**Re: Huntington Beach Energy Project (12-AFC-03)
Air Quality Correspondence dated March 25, 2013**

**Subject: Huntington Beach Energy Project Permit Application (Facility ID# 115389)**

AES Huntington Beach, LLC (AES-HB) is submitting this letter in response to the South Coast Air Quality Management District's (AQMD) February 19, 2013 request for additional information needed to complete the engineering evaluation and finalization of the Preliminary Determination of Compliance for the Huntington Beach Energy Project (HBEP). The remainder of this letter presents AES-HB's responses to the requested information.

FIGURE 1  
**Costa Mesa 5-year Wind Rose**

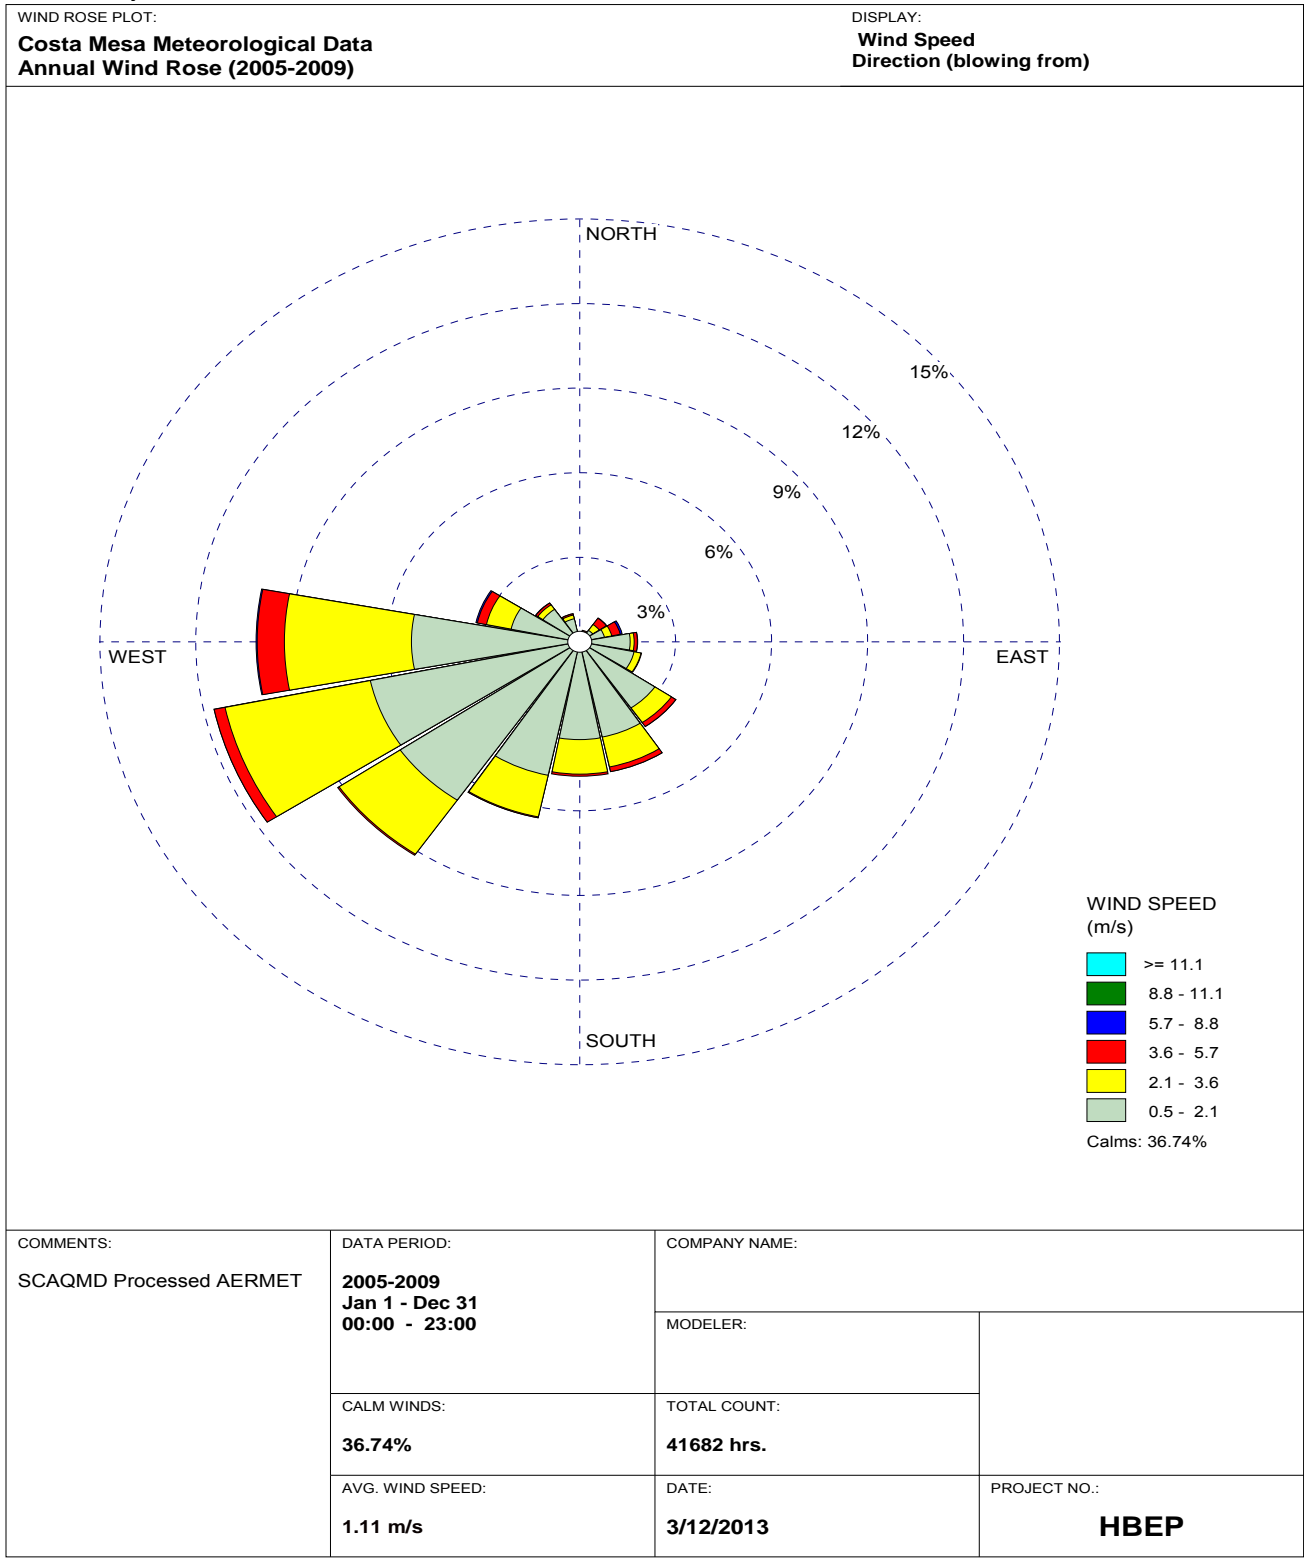
- A 5-year meteorological dataset is required for all Prevention of Significant Deterioration (PSD) projects. The AQMD will provide those files along with the ozone files in a subsequent communication.
- Based on your dispersion modeling analysis, the HBEP will exceed the significant impact level (SIL) for the Federal 1-hour nitrogen dioxide (NO<sub>2</sub>) standard. This will require a cumulative analysis of ambient impacts for NO<sub>2</sub>. As I explained in our phone conversation, the overly conservative nature of the Federal 1-hour NO<sub>2</sub> project impact analysis contained in your report would cause a larger area within the project impact contour than is necessary when performing the cumulative impact

AERMOD will be modeled with 5 years of data collected at the Costa Mesa meteorological monitoring station, owned and operated by the SCAQMD. This station was selected because it is very near the project site (6 km north east of the project site) and the winds are considered representative of the area. Five complete years of meteorological data collected from 2005 to 2009 were processed by SCAQMD with the AERMET meteorological data preprocessor. Figure 1 shows the 5-year wind rose for the Costa Mesa station.
